Responses to Comments
Public Review of Merrimack Station
NPDES Permit No. NH0001465

U.S. Environmental Protection Agency
5 Post Office Square
Boston, Massachusetts 02109

Comment VIII.2.5	AR-1231, PSNH, p. 20

Figure - Overlay of Power Plants and Findings of *Corbicula Fluminea*²⁸³

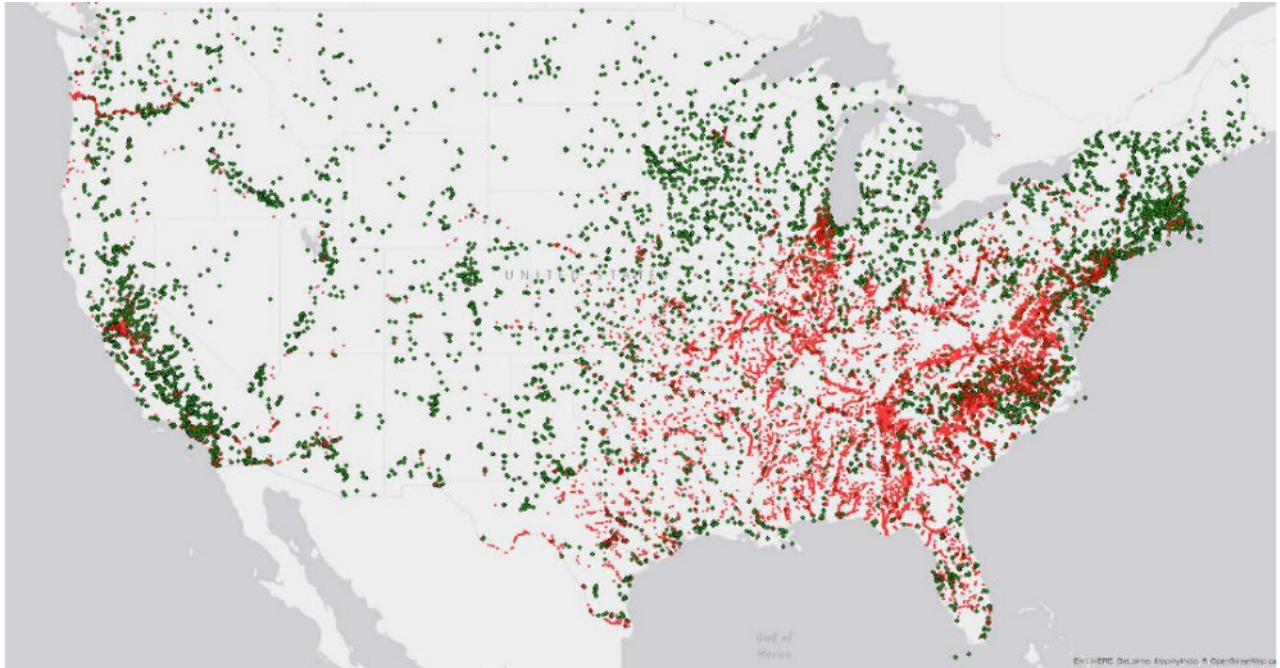
The red dots shown on the map represent Asian clam locations reported in the United States Geological Survey (USGS) database.²⁸² Further, the Asian clam is extensively found near power plants (shown in green):

Given EPA's silence concerning the Asian clam despite receiving the findings of Normandeau that Hooksett Pool hosts a healthy, BIP of fish and macroinvertebrates, PSNH did not anticipate EPA's interest in the Asian clam until learning of it by happenstance approximately three years ago. In 2014, PSNH observed EPA conducting dives, unannounced, with NHDES in the immediate vicinity of Merrimack Station. Near this same time period, EPA responded to several Freedom of Information Act ("FOIA") requests issued by PSNH concerning the Merrimack Station permit proceeding.²⁸⁴ Although EPA never mentioned its interest in the Asian clam to PSNH, its permit holder, documents contained within EPA's FOIA production made clear EPA had fixed its focus on the Asian clam, almost to the exclusion of other species. As a mounting number of documents from EPA's FOIA production focused on the Asian clam, PSNH grew concerned EPA might be considering a new basis to attempt to shore up the fatally flawed Draft Permit and its denial of PSNH's § 316(a) variance request that were based on EPA's erroneous determination that the polluted Merrimack River of the 1960s hosted a BIP and was the appropriate baseline for comparison.²⁸⁵ Indeed, documents included in one of EPA's FOIA productions revealed that, in September 2015, EPA had contemplated a dive study for the purpose of assessing the Asian clam's effect on the Hooksett Pool BIP.²⁸⁶ As explained in this "Project Plan" document, EPA sought to improve its "understanding of the power plant's influence on this invasive species" and, in turn, to "evaluate the plant's ability to meet state and federal water quality standards, and its NPDES permit requirements, as they apply to protecting the resident biological communities."²⁸⁷ Among its study objectives, EPA planned to "assess the abundance of *Corbicula* relative to native epifaunal and infaunal macroinvertebrates," in addition to "*Corbicula*'s capacity to displace native invertebrates, including mussels."²⁸⁸ However, EPA's study plan was abandoned and the evaluation was never undertaken.²⁸⁹

Figure 4-1. Percent withdrawal versus total number entrained during Merrimack River entrainment studies (2006-2007) (Normandeau 2007b).

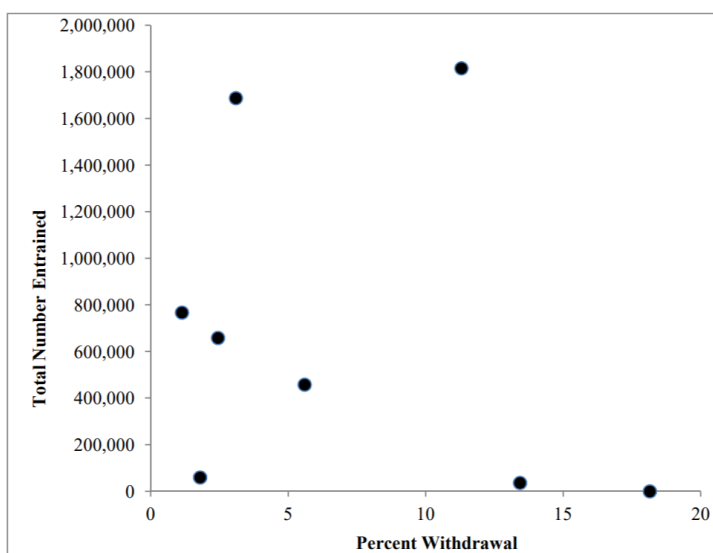
[Responding to AR-618, p. 245 Section 11.2.1a] USEPA provides no evidence for the assertion that eggs and larvae are equally distributed throughout the river. In fact, the peer-reviewed scientific literature indicates that ichthyoplankton have a very patchy spatial and temporal distribution. USEPA provides no basis for its assumption that the percent of water withdrawn for cooling can provide an estimate of the percentage of the ichthyoplankton lost to entrainment. The percentage of the water withdrawn is a factor in determining entrainment, but density of ichthyoplankton in Hooksett Pool over space and time are also important factors. Existing entrainment and withdrawal data do not support the Agency's assumption that entrainment is proportional to percent water withdrawal because the months with the greatest percentage withdrawal are also the months with the lowest ichthyoplankton densities. Figure 4-1 presents a plot of percent withdrawal on the x axis versus total entrainment on the y axis (Table 3-7; Normandeau 2007b). There is no apparent positive relationship between percent withdrawal and total monthly entrainment. In fact, a non-parametric Spearman Rank Correlation analysis indicates that there is a negative relationship (-0.41) between percent withdrawal and total monthly entrainment. The raw data are presented in Table 4-1. The months with the greatest percent withdrawal, August and September 2006, also have the lowest entrainment because ichthyoplankton are not common in Hooksett Pool during those months. The highest entrainment occurred in June of 2006 and 2007 when percent withdrawal was relatively low (June 2006), or

above average (June 2007) but entrainment was highest due to the high density of ichthyoplankton in Hooksett Pool. The conclusion to be drawn from this analysis of empirical data is that percent water withdrawal alone is not a major factor in determining entrainment at Merrimack Station. Density of ichthyoplankton in Hooksett Pool is also an important factor and the greatest percent withdrawals occur in the months when ichthyoplankton density is low. It can be seen that during May, low ichthyoplankton densities are the norm, and that the entrainment estimate for May at Unit 2 is driven by the relatively large amount of ichthyoplankton collected on the night of 31 May (Table 4-2). The data from the night of 31 May might be considered the outlier rather than the 0 counts at Unit 1, but Normandeau included all data in the analysis because there are no methodological reasons to exclude them. Empirical data should not be excluded because it appears to be “different,” but may only be excluded if there is some methodological reason that would justify the exclusion, such as abnormal field sample collection or mishap during laboratory analysis. These incidents did not occur. Therefore, USEPA’s rationale for excluding the data for Unit 1 from May, and substituting the Unit 2 data for the Unit 1 data is not valid. Normandeau’s data estimated 3.2 million larvae per year were entrained, and USEPA improperly changed this number to 3.8 million larvae entrained.
